Environmental Protection Authority
Expert Consenting Panel
Drury Metropolitan Centre Consolidated Stages 1 and 2

21 October 2025

DRURY METROPOLITAN CENTRE CONSOLIDATED STAGES 1 AND 2 –TRAFFIC PEER REVIEW

Figure 3: Flanagan Road upgrade (combined)

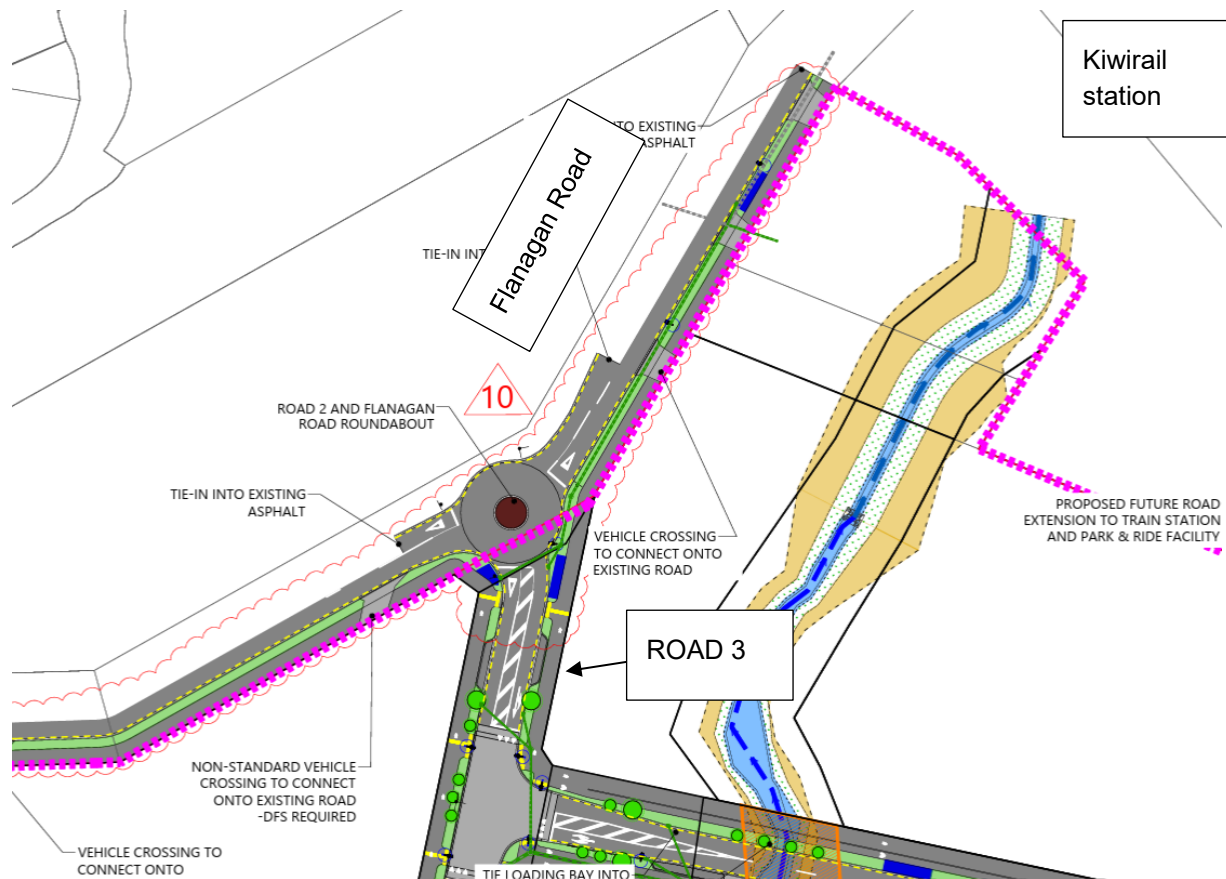
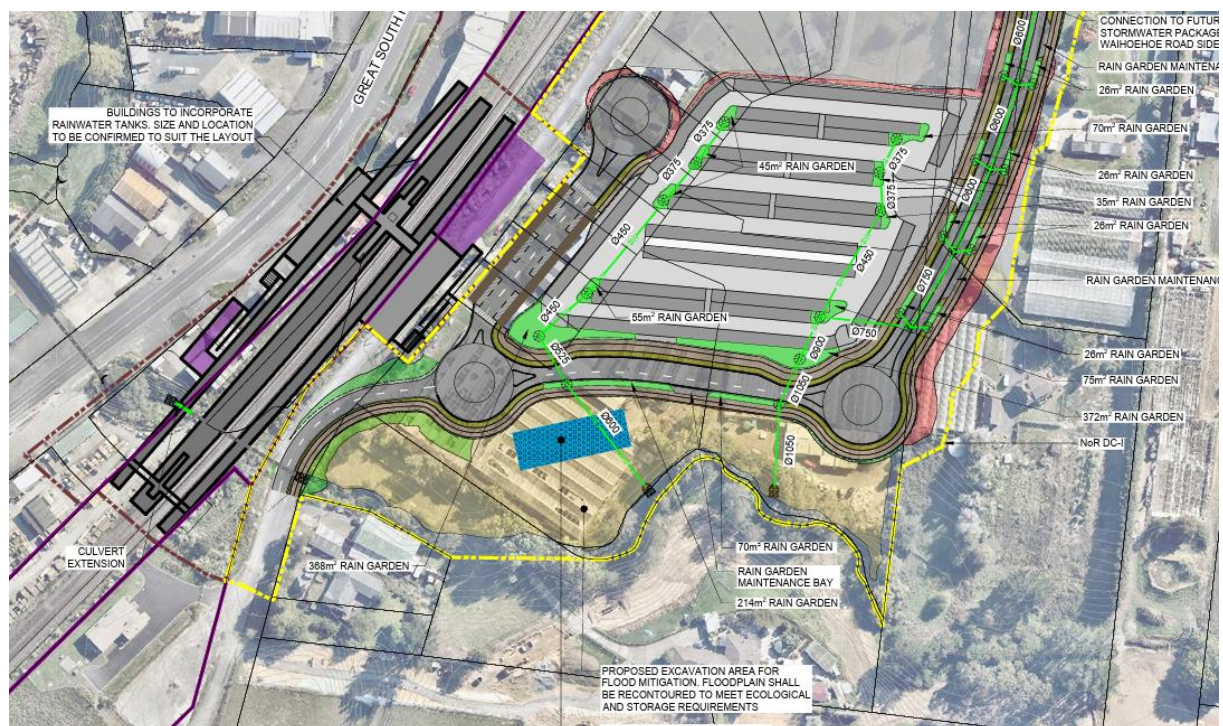
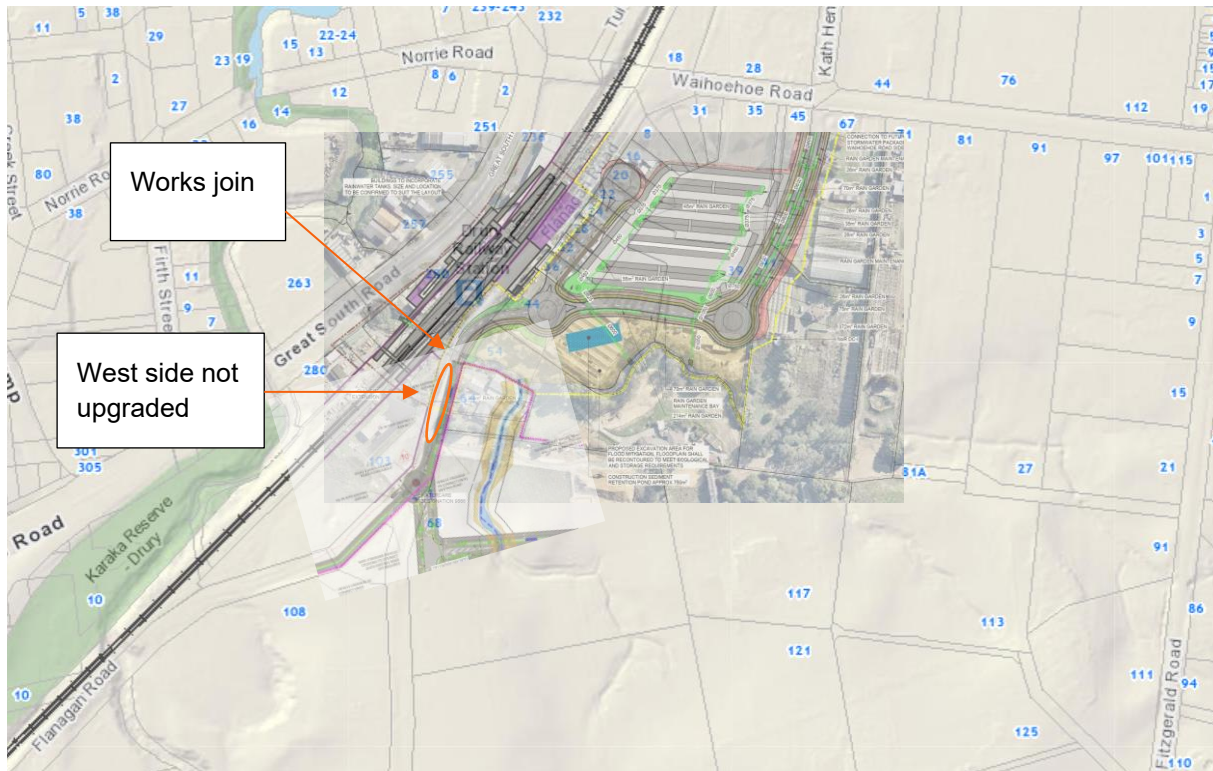
It appears on the information provided by Kiwi Property that a portion of the road will be upgraded but only upgraded on one side. From the information available from Kiwirail relating to the Drury Centre train station it appears that the proposed carriageway extents meet. These designs are shown in Figure 1 and 2 below.

I have subsequently attempted to join both drawings together in Figure 3 below. It appears that both works meet each other however as currently proposed there would be a short section (approximately 150m long) where only one side of the road will be upgraded (with the remainder being upgraded both sides).

- The applicant is joining the footpath to the Rail station
- The applicant has joined Flanagan Road to the rail station
- Typically, as greenfield development progresses only the subject side of the road frontage is constructed (as proposed), with the adjacent side left to a future developer.
- In this case I consider it unlikely that the western side will be urbanised by another developer given it appears to be a Watercare asset and thus re-development is unlikely.

- viii. There is a small section of Flanagan Road (Figure 3) that will remain in existing formation when both the Kiwirail and current application construct their sections. This is considered undesirable and should be upgraded as part of the application (carriageway only and not kerb / channel on the western side). This has now been conditioned in the applicant latest condition set.

Overall, it is my opinion that both sides of the road along Flanagan Road should be upgraded by the application. This should only be the carriageway formation (ie not kerb an channel / footpath on the western side). I note the applicant has now proposed a revised condition and provided a revised plan that shows this full upgrade.
